SUBJECT: Contract No. DE-AC24-03OH20152  
Contract Deliverable 039 – PRS Documents  
**CONTINGENT REMOVAL ACTIONS FOR CONTAMINATED SOILS -  
ADDENDUM 1: STRUCTURES, PUBLIC REVIEW DRAFT**

**RESPONSE TO OHIO ENVIRONMENTAL PROTECTION AGENCY  
COMMENTS OF MARCH 26, 2004 ON  
CONTINGENT REMOVAL ACTION FOR CONTAMINATED SOILS  
ADDENDUM 1: STRUCTURES  
FEBRUARY 2004, DRAFT**

## RESPONSE TO U.S. EPA COMMENTS

Figure 2

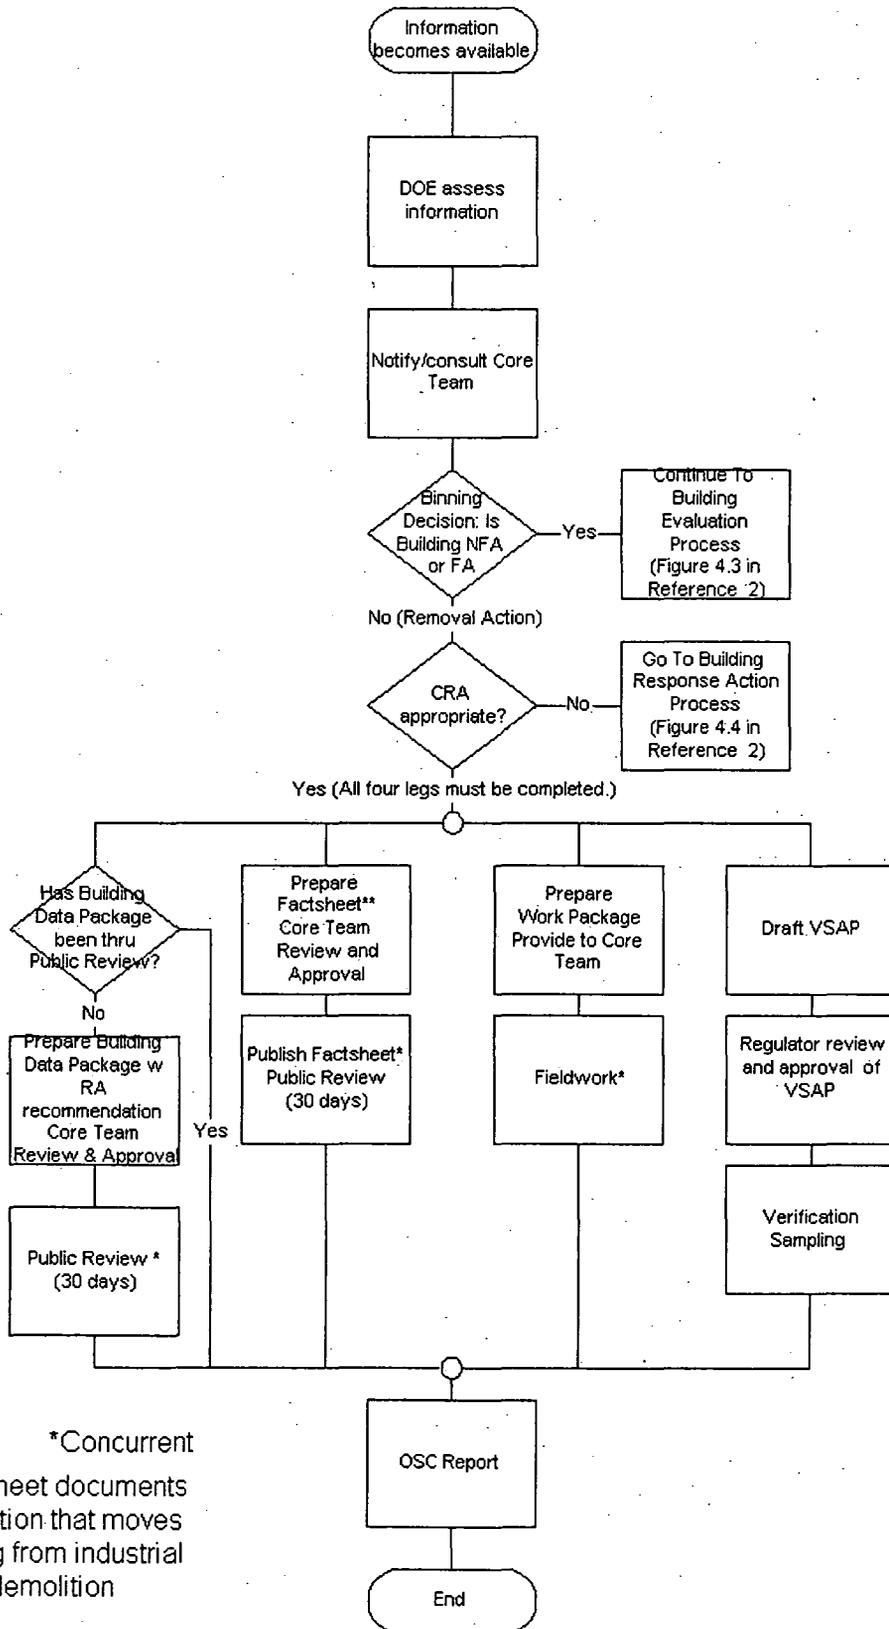
- 1). A Flow Chart must be provided to illustrate how the building will be process.  
(Refer to: Work Plan for Environmental Restoration of the DOE Mound Site, The Mound 2000 Approach)

Link "Continue to Building Evaluation Process" to Mound 2000 Work Plan

Link "Go To Building Response Action Process" to Mound 2000 Work Plan

Change "Prepare Factsheet Core Team Review" to "Prepare Factsheet Core Team Review and Approval"

Remove (30day) from Regulator Review and Approval of VSAP (30day)

Add footnote indication Factsheet documents the new information that "moves" the building into the CRA process.

The attached flowchart illustrates the CRA process for buildings. This flowchart will be included in the addendum. The following sentence was added to the last paragraph of the Purpose section. "A flowchart that illustrates the CRA process for buildings (other than Building 30 and Building 50 red drain line) is included as Figure 2."

Per Telecon 4/2/04, OEPA would like BDP with Factsheet for information. The flow chart was revised accordingly.
